## Determination 2018/003

# The refusal to issue a code compliance certificate for a 13-year-old house with mixed claddings at 707C Great North Road, Grey Lynn, Auckland

**Figure 1: Approximate site plan**

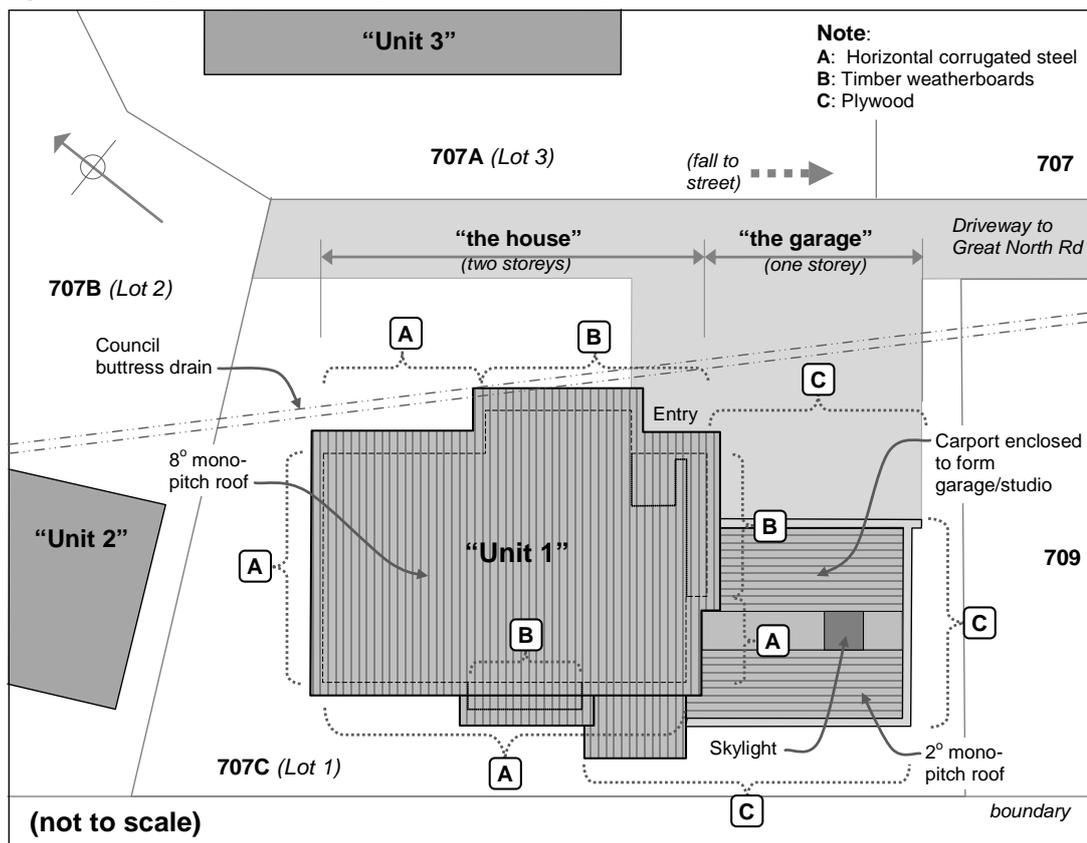
- 2.2.1 The garage walls are clad in plywood fixed through the building wrap directly to the framing timbers (cladding “C” in Figure 1). Timber battens are fixed over vertical joints, with a metal flashing over the horizontal joint.

- 2.2.2 The wall cladding to the east corner and to the southwest projecting bay is horizontal bevel-backed timber weatherboards (cladding “B” in Figure 1), fixed through the building wrap directly to the framing timbers. Timber facings frame the windows, with flashings over head facings, scribes to jamb facings and a sloped top to sill facings.

- 2.2.3 The remaining walls of the house are clad in horizontal corrugated steel (cladding “A” in Figure 1) fixed through the building wrap directly to the framing timbers. Proprietary folded metal flashings are installed at corners and other junctions. Flat riveted steel sheet form ‘facings’ around windows and doors, with metal head flashings underlapping head facings.
